CIRCUIT COMPARISON

ChryslerScanner

Original schematic -> current circuit sets

Original: Daniel Laszlo, revision 2.4.0-1, 2026-01-05. Current: Rev C, 24 pages / 329 circuit-probe endpoints.

01 Vehicle battery input

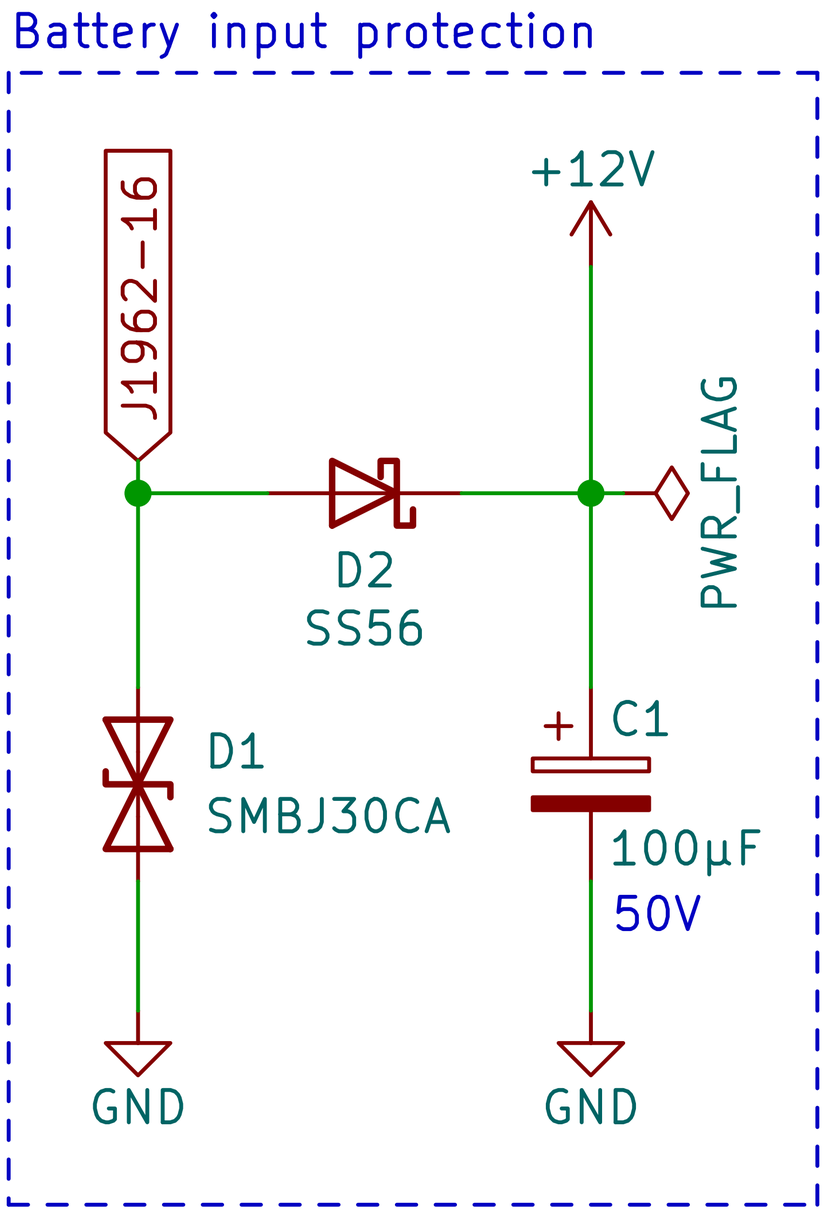
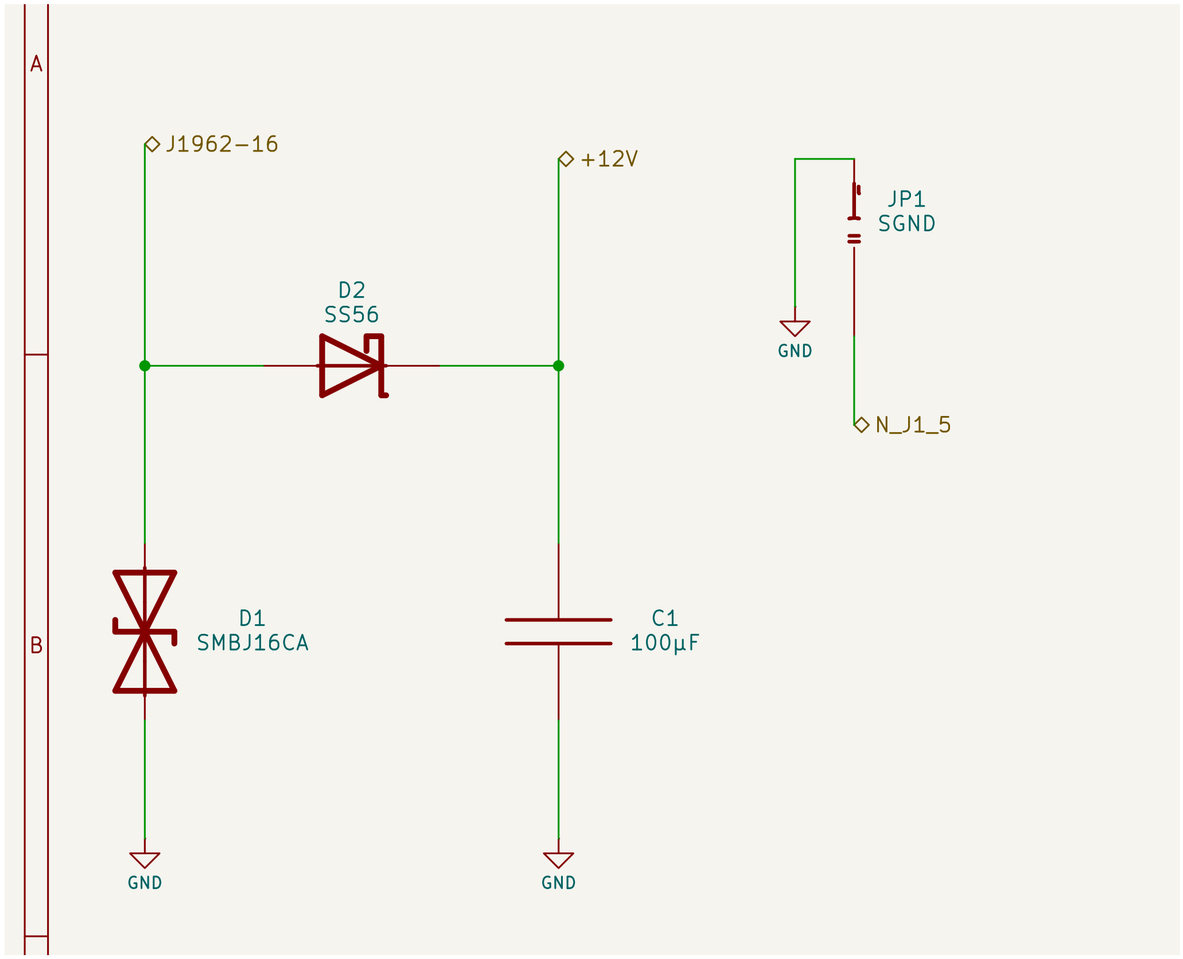
- D1 changes from SMBJ30CA to SMBJ16CA. D2, C1 and the JP1 signal-ground link remain.
- The battery ADC now senses protected +12V after D2, rather than raw J1962-16. This is an intentional safety change.

02 OBD connector and line protection

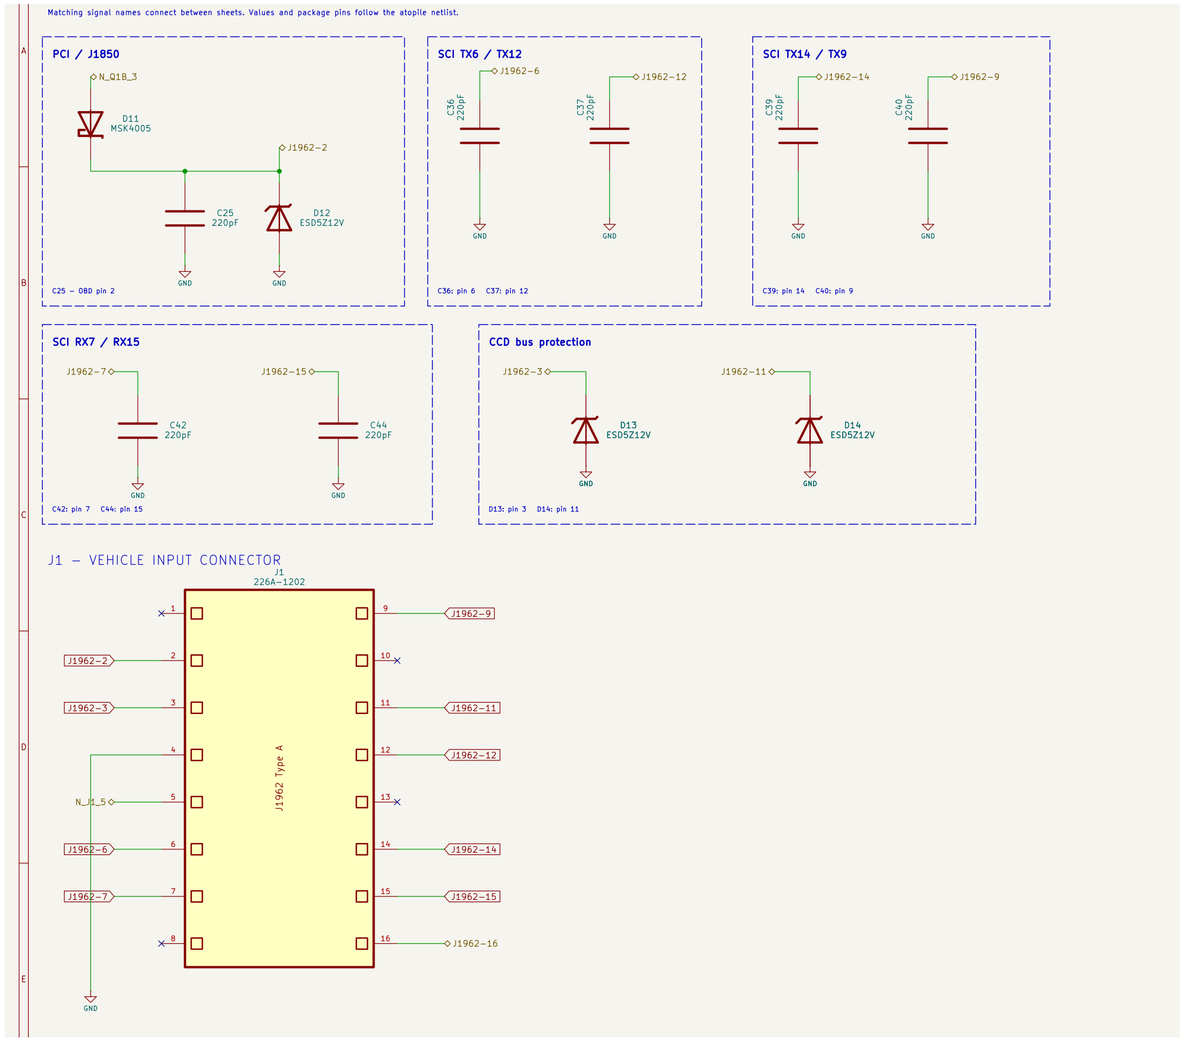
- J1 is now an ATTEND 226A-1202; logical vehicle pin assignments are retained.
- Capacitors and protection diodes formerly scattered across bus blocks are grouped by PCI, SCI and CCD on one page. These crops identify their original locations.

03 USB connector and power selection

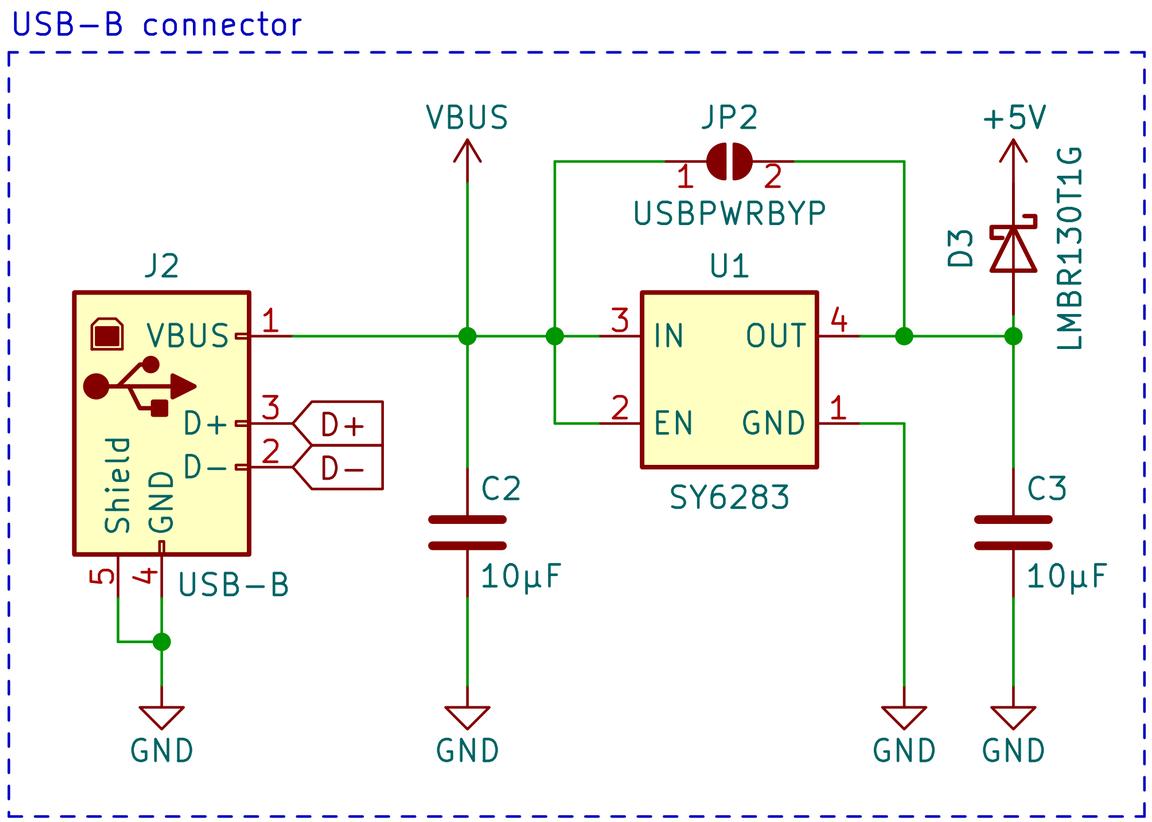
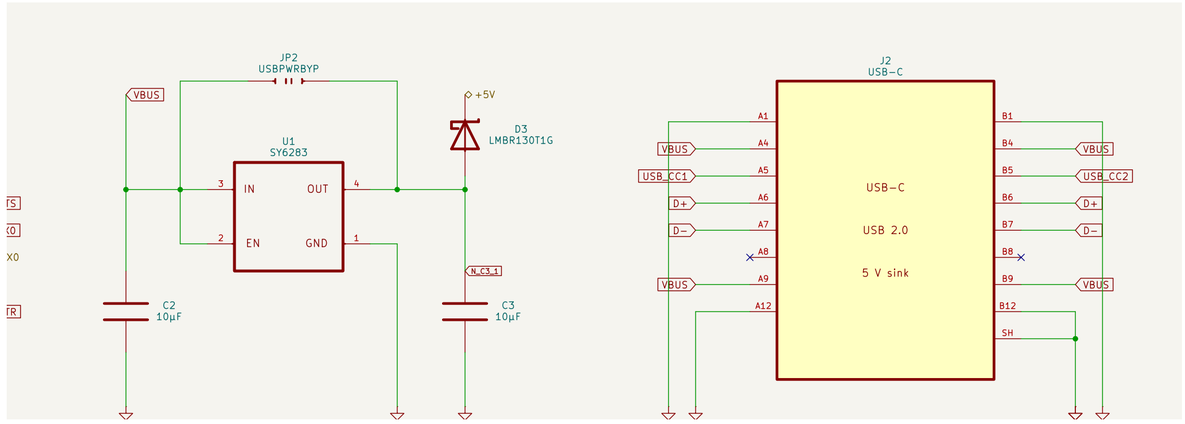
- USB-B is deliberately replaced by USB-C, with separate CC pull-down resistors R102/R103.
- U1 SY6283 power switching, JP2 bypass, D3 and the input/output capacitor functions remain. See comparison 11 for UART/ESD circuitry.

04 6 V pre-regulator and +5 V output

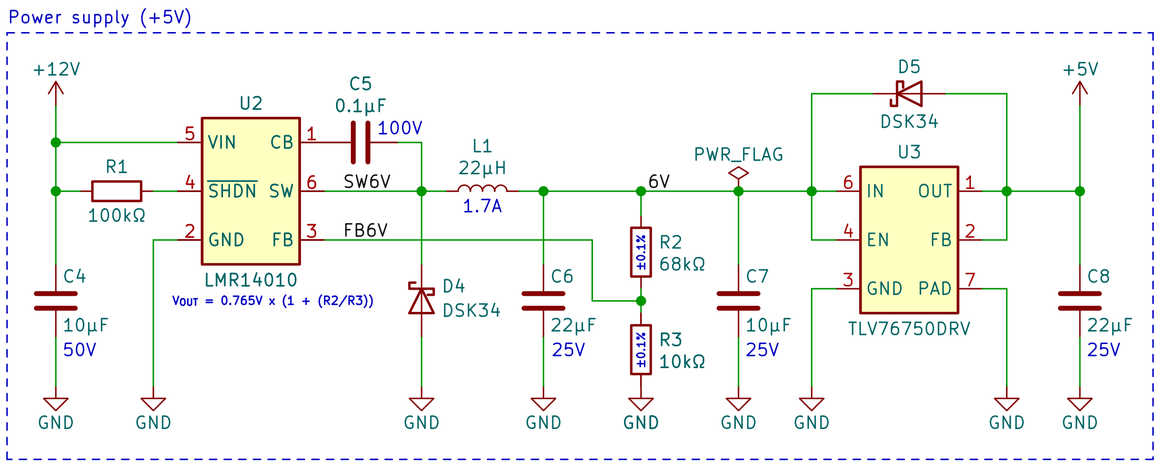
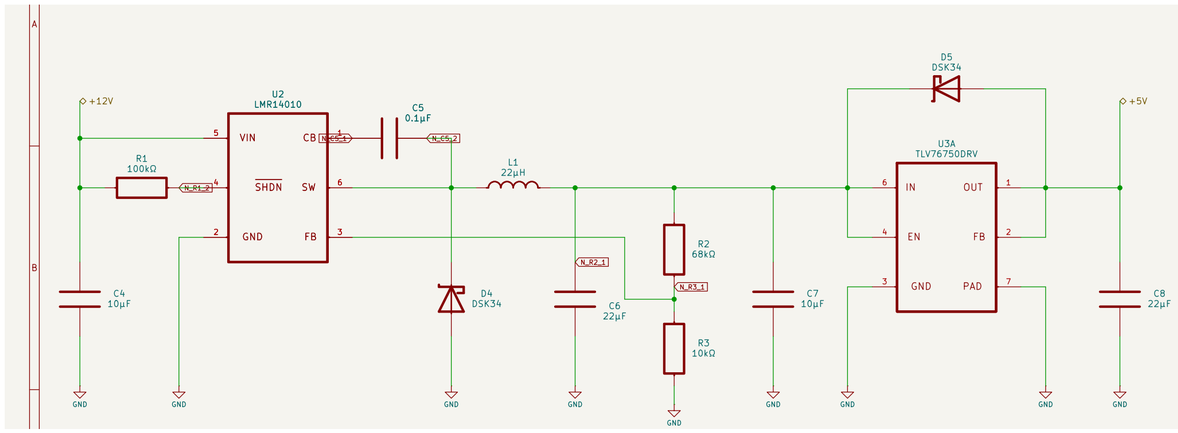
- U2, L1, D4/D5, U3 and feedback/output-sense functions correspond to the original block.
- The migrated regulator symbol library exposes electrical units/pins explicitly; compare named IN, OUT, FB, SNS and EN connections rather than symbol appearance.

05 +3.3 V logic supply

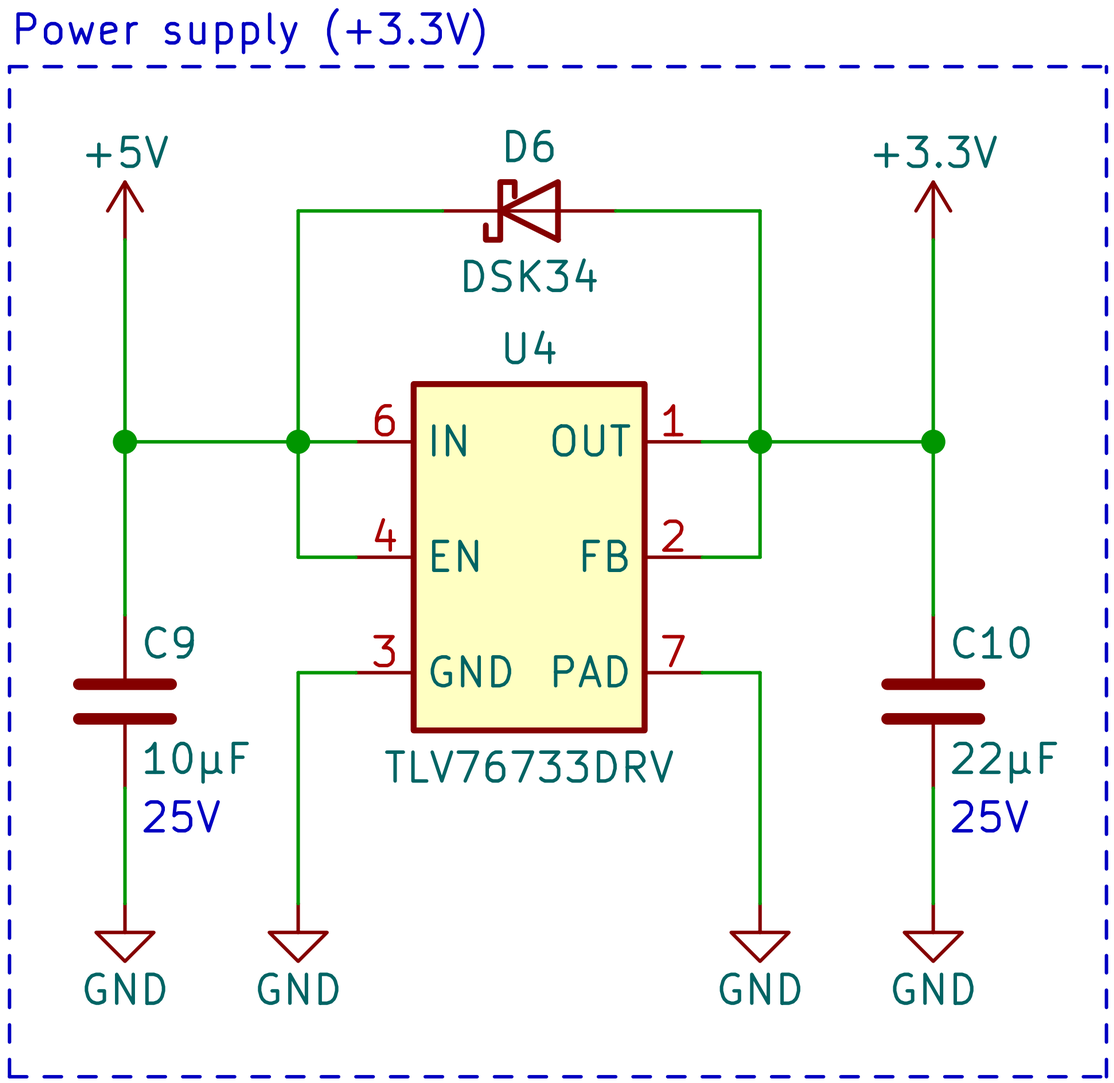
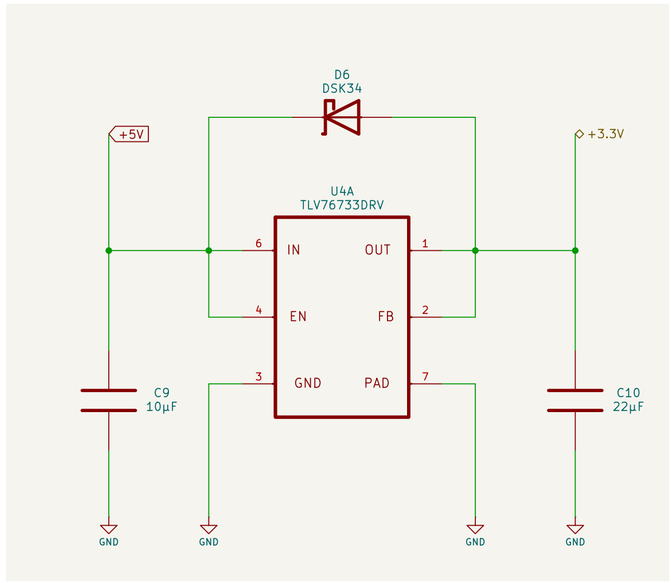
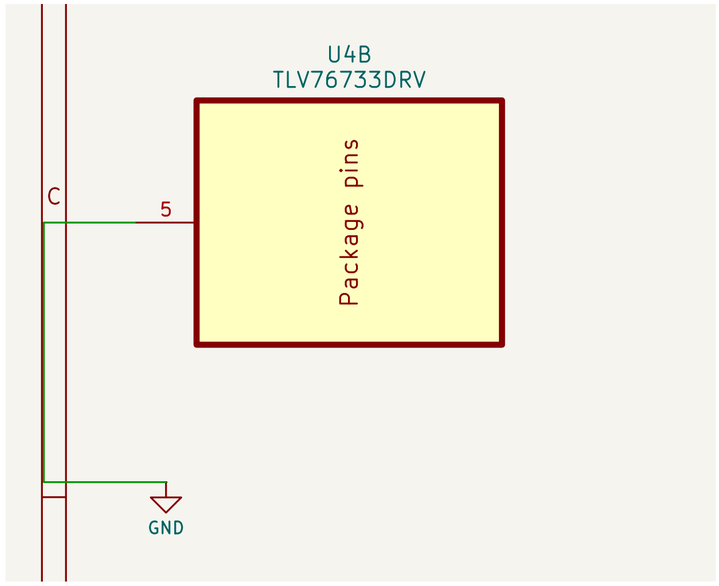
- The original +3.3 V regulation and filtering remain. The additional displayed symbol unit belongs to the same U4 package.
- The separate SD_3V3 regulator is a later addition, not a replacement for this logic supply.

06 VPP programming boost supply

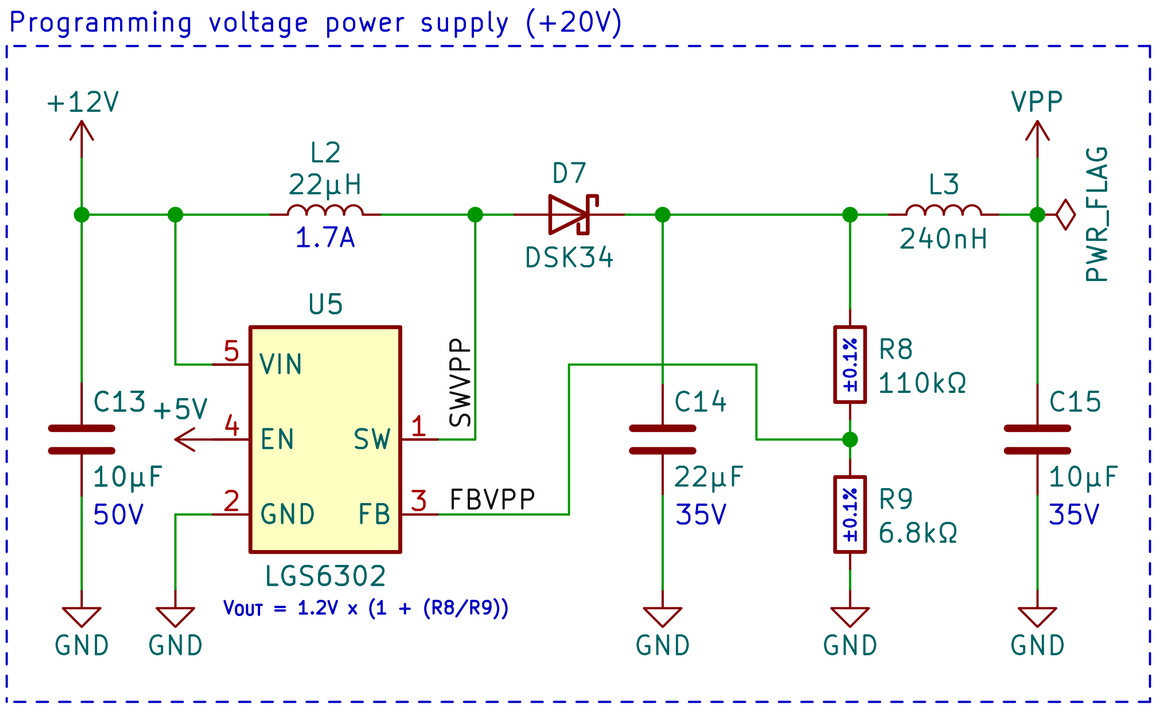
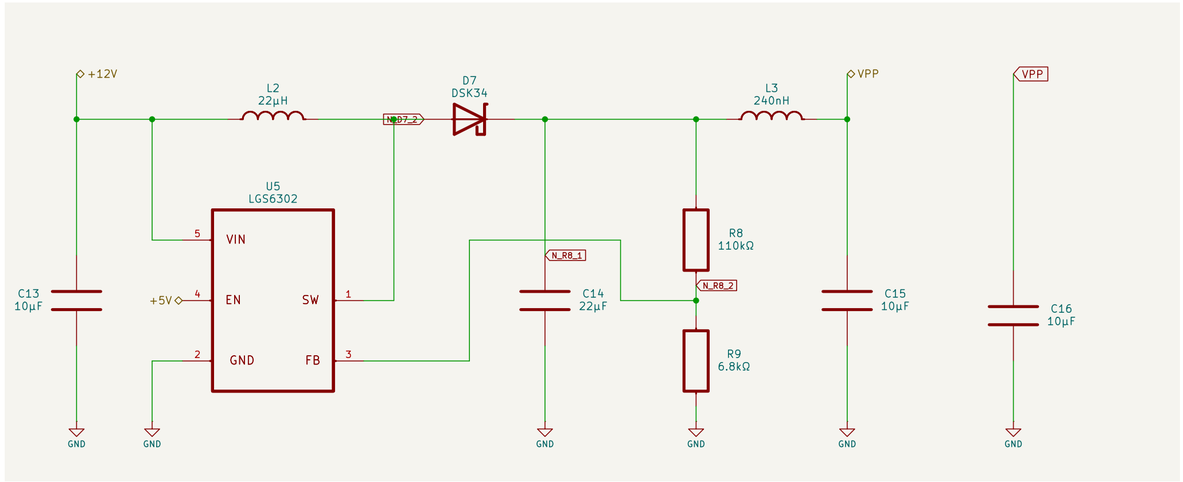
- The original boost topology and programming-rail function remain.
- C14 and C15 now specify at least 50 V, deliberately increased from the original 35 V labels. The bounded prototype still requires protected-input/VPP peaks at or below 28 V.

07 VBB bootstrap supply

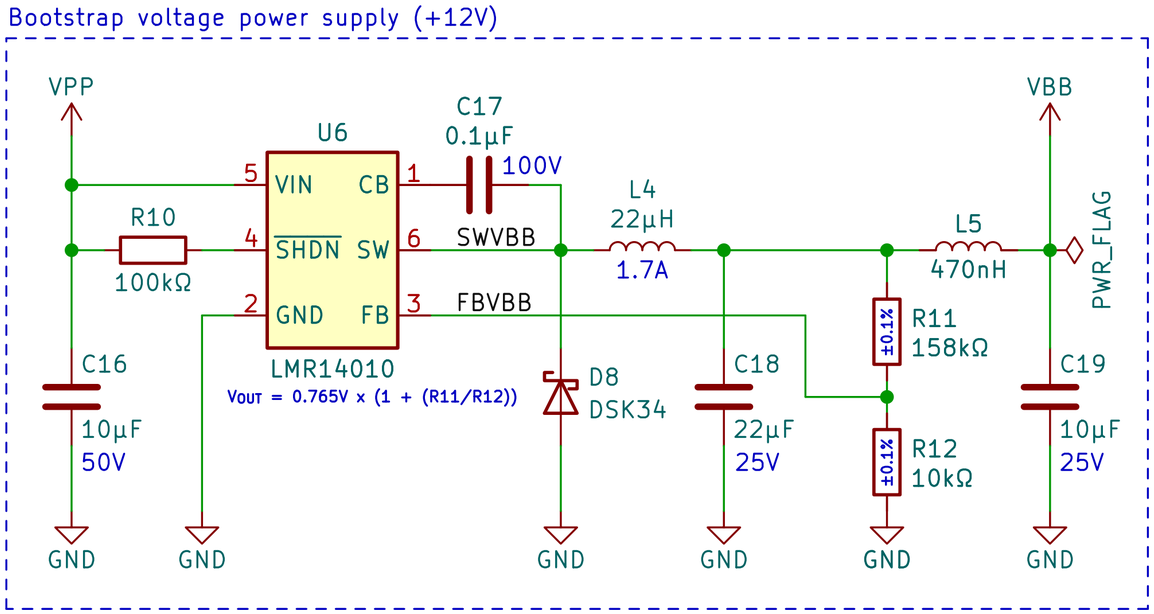
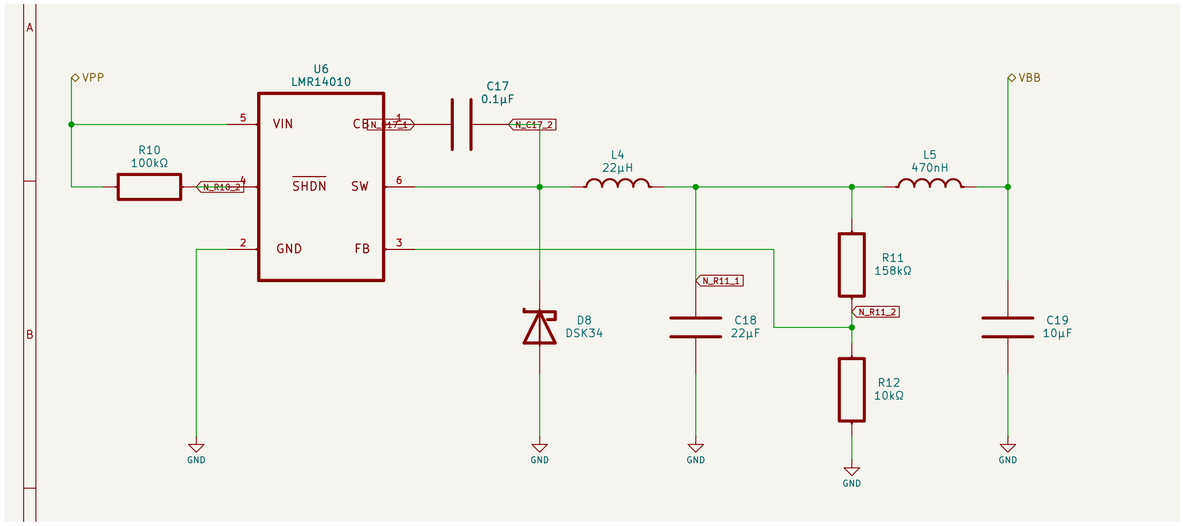
- The original VBB rail and feedback/output-filtering blocks correspond directly.
- The page title refers to the rail function; original reference designators and named VBB connections identify the match.
